SUBJECT: INSTALLATION OF A HARDENED WETWELL VENT (GENERIC LETTER 89-16)

License DPR-35  
Docket 50-293

**REVISED INFORMATION REGARDING PILGRIM STATION  
SAFETY ENHANCEMENT PROGRAM**

Section 3.2 Revision 1 "Installation Of A Direct Torus Vent System (DTVS)"

FIGURE 3.2-1

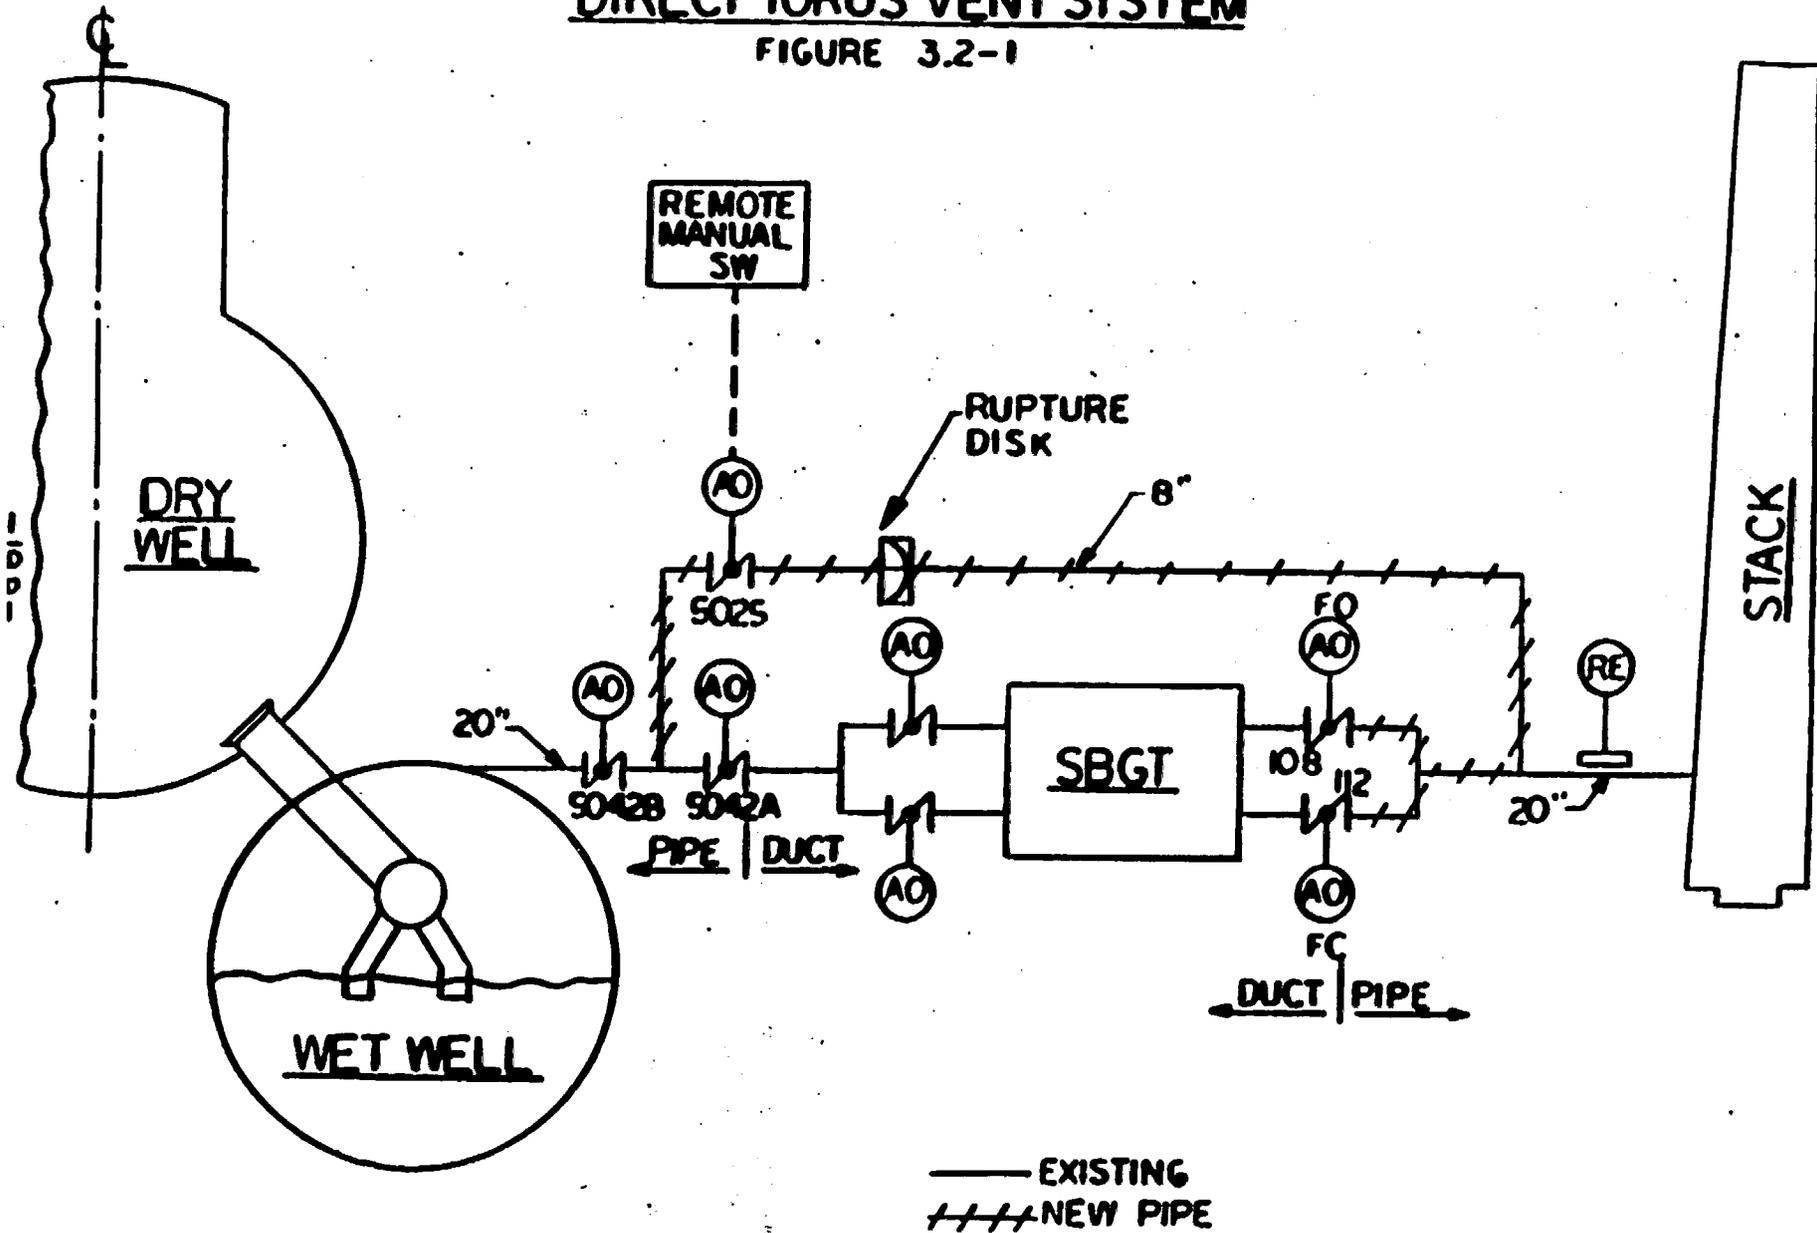
This design change (Figure 3.2-1) provides a direct vent path from the torus to the main stack bypassing the Standby Gas Treatment System (SBGTS). The bypass is an 8" line whose upstream end is connected to the pipe between primary containment isolation valves AO-5042 A & B. The downstream end of the bypass is connected to the 20" main stack line downstream of SBGTS valves AON-108 and AON-112. An 8" butterfly valve (AO-5025), which can be remotely operated from the main control room, is added downstream of 8" valve AO-5042B. This valve acts as the primary containment outboard isolation valve for the direct torus vent line and will conform to NRC requirements for sealed closed isolation valves as defined in NUREG 0800 SRP 6.2.4. The new pipe is ASME III Class 2 up to and inclusive of valve AO-5025. Test connections are provided upstream and downstream of AO-5025.

The design change replaces the existing AC solenoid valve for AO-5042B with a DC solenoid valve (powered from essential 125 volt DC) to ensure operability without dependence on AC power. The new isolation valve, AO-5025, is also provided with a DC solenoid powered from the redundant 125 volt DC source. Both of these valves are normally closed and fail closed on loss of electrical and pneumatic power. One inch nitrogen lines are added to provide nitrogen to valves AO-5042B and AO-5025. New valve AO-5025 will be controlled by a remote manual key-locked control switch. During normal operation, power to the AO-5025 DC solenoid will also be disabled by removal of fuses in the wiring to the solenoid valve. This satisfies NUREG 0800 SRP 6.2.4, Containment Isolation System acceptance criteria for a sealed closed barrier. An additional fuse will be installed and remain in place to power valve status indication for AO-5025 in the main control room.

A 20" pipe will replace the existing 20" diameter duct between SBGTS valves AON-108, AON-112 and the existing 20" pipe to the main stack. The existing 20" diameter duct downstream of AO-5042A is shortened to allow fitup of the new vent line branch connection.

A rupture disk will be included in the 8" piping downstream of valve AO-5025. The rupture disk will provide a second leakage barrier. The rupture disk is designed to open below containment design pressure, but will be intact up to pressures equal to or greater than those which cause an automatic containment isolation during any accident conditions.

The two Primary Containment Isolation Valves (PCIVs) AO-5042B and AO-5025 are placed in series with the rupture disk. No single operator error in valve operation can activate the DTVS. The rupture disk has a rupture pressure above the automatic containment high pressure trip point. Thus, the inboard PCIV (AO-5042B) will receive an automatic isolation prior to disk rupture. The inboard PCIV (AO-5042B) requires physical electrical jumper installation to open at primary containment pressure above the automatic high pressure trip point.
